80960SA/SB SPECIFICATION UPDATE

Release Date: July, 1996

Order Number: 272850-001

Figure 1. Block Diagram of Workaround

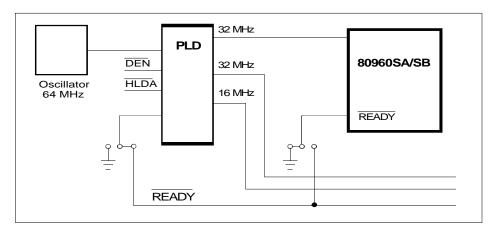
9600001. Byte Enables Switch Prematurely with Wait States

PROBLEM: During many accesses with wait states, the BE1:0# signals incorrectly switch after the first Tw state. The affected accesses include:

WORKAROUND: Do not use the READY# input; tie it to a LOW logic state. If wait states are necessary, gate the input clock using external logic.

Figure 1 illustrates example workaround logic. A programmable logic device (PLD) driven by a 4X clock oscillator provides a 2X clock for the 80960SA/SB and other system clocks. READY# is an input to the PLD which stops the 2X clock whenever it is asserted. When READY# is deasserted, the PLD resynchronizes the 2X clock to the system clocks. Figure 2 is a state diagram of the workaround.

The 80960SA/SB has dynamic registers, so do not stop its input clock for more than about one microsecond. This restriction limits the number of wait states to about nine for a 10 MHz 80960SA/SB.
